Form 504	
U. S. COAST AND GEODETIC SURVEY	
DEPARTMENT OF COMMERCE	
DESCRIPTIVE REPORT	
Type of Survey <u>Shoreline</u>	
Field No.	Office No. <u>T-9123</u>
LOCALITY	
State <u>Alaska</u>	
General locality <u>Prince William Sound</u>	
Locality <u>McClure Bay</u>	
<u>1954</u>	
CHIEF OF PARTY	
Office: <u>L. W. Swanson</u>	
LIBRARY & ARCHIVES	
DATE

SUMMARY TO ACCOMPANY
DESCRIPTIVE REPORT T-9123

REVIEW REPORT T-9123

Comparison Print

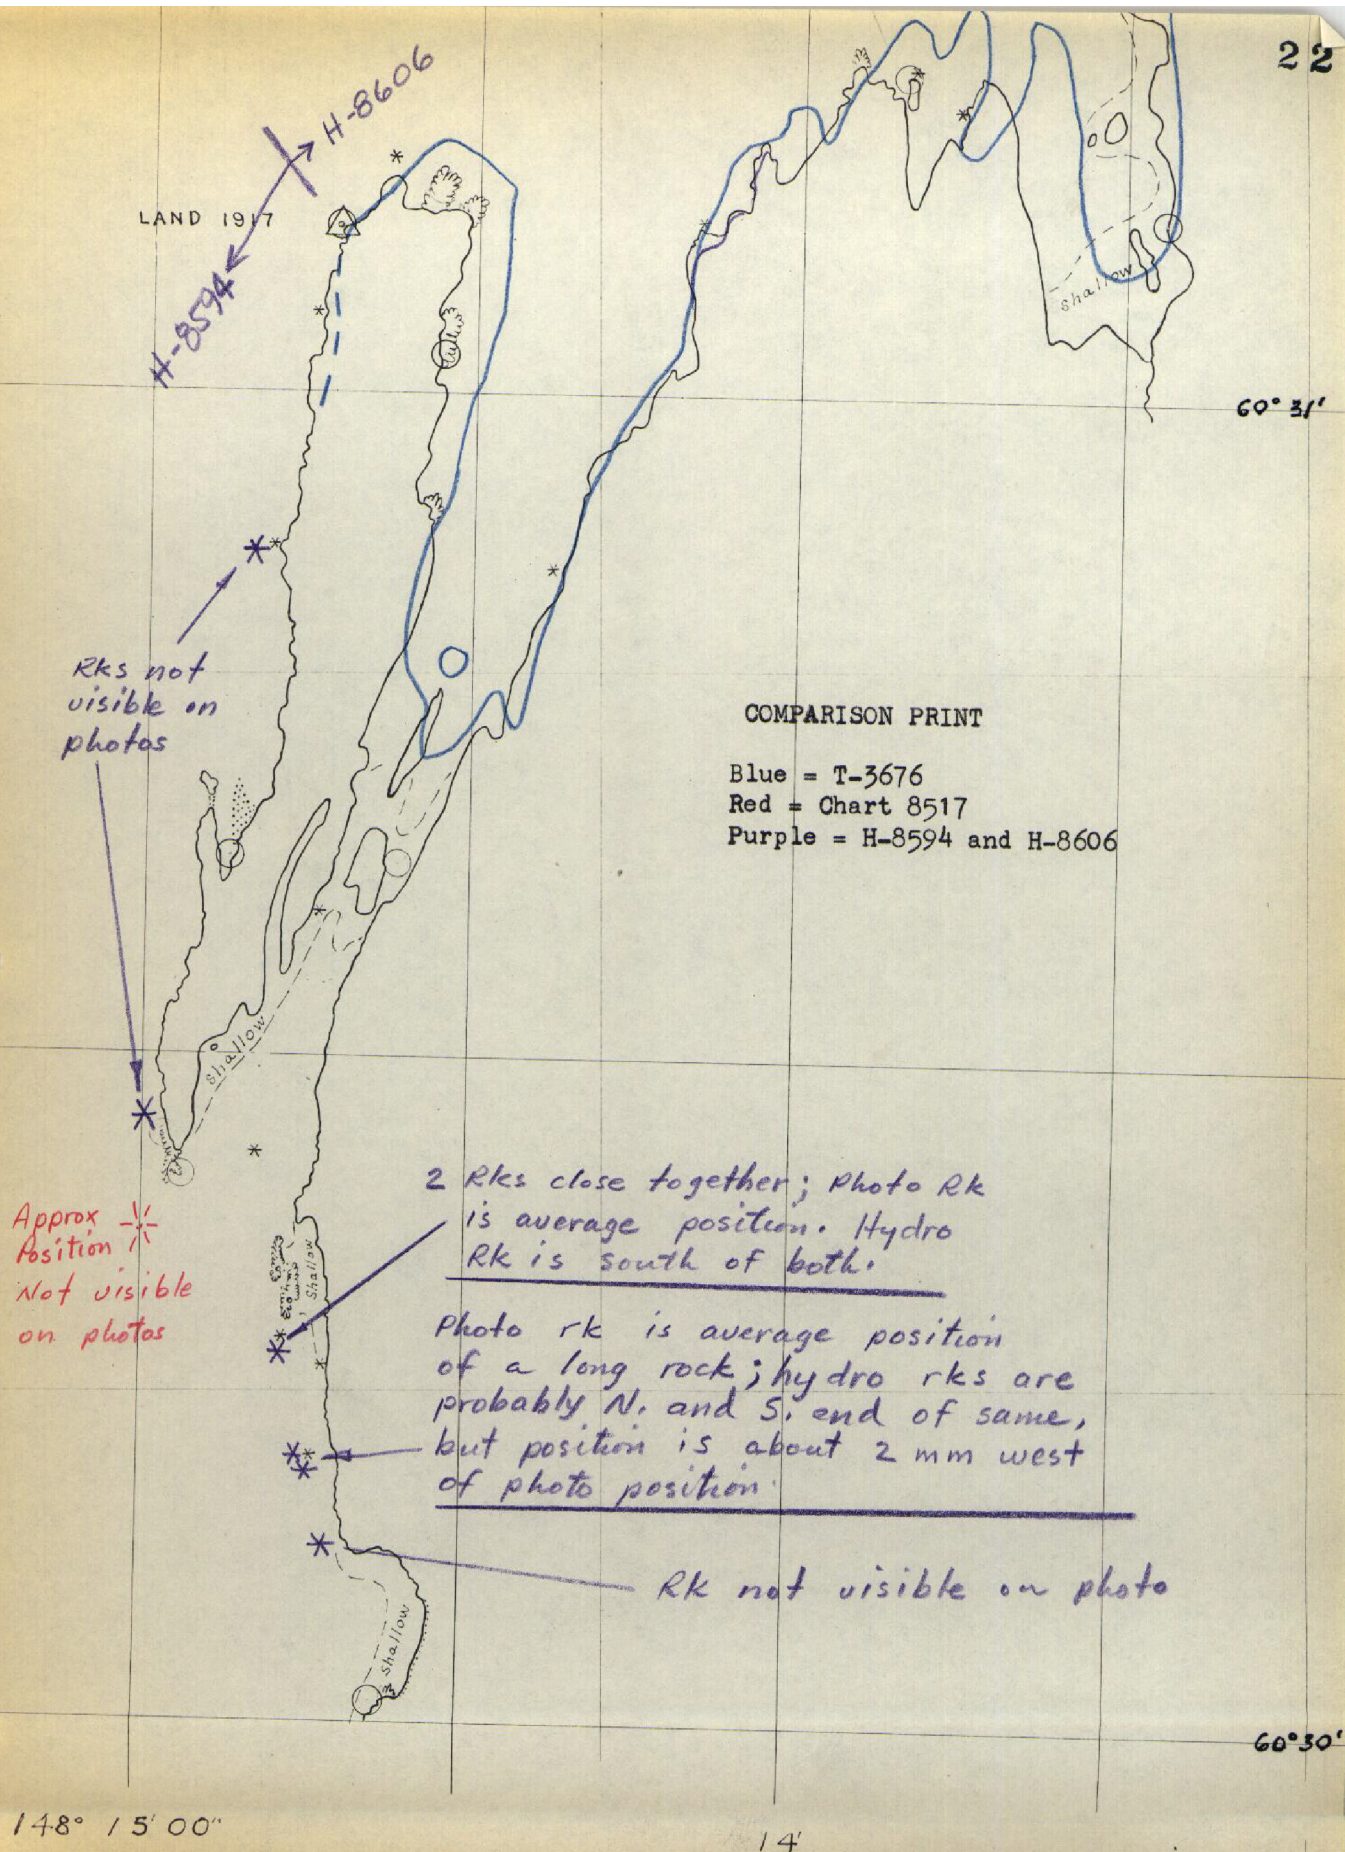
Blue = T-3676

COMPARISON PRINT

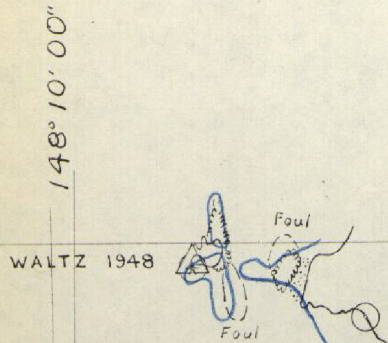
Blue = T-3676
Purple = H-8606

Only one rock
visible on photos

COMPARISON PRINT

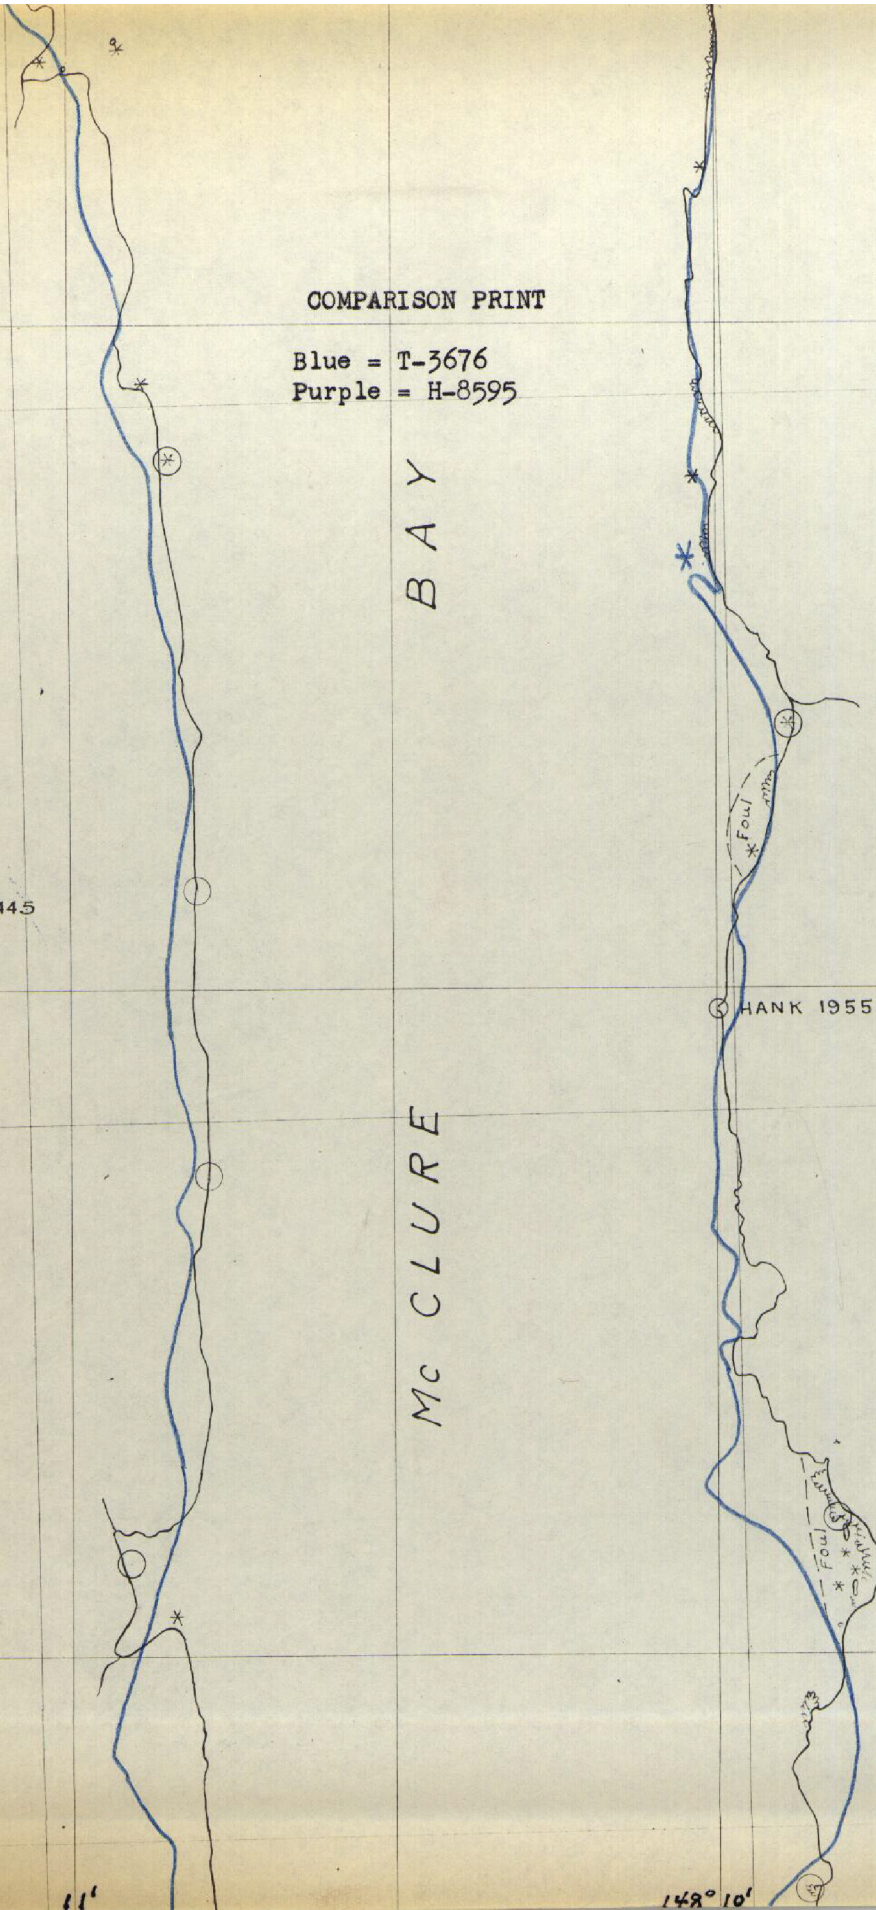
Blue = T-3676
Purple = H-8595

H-8595 revised

only one Rk
visible on photo
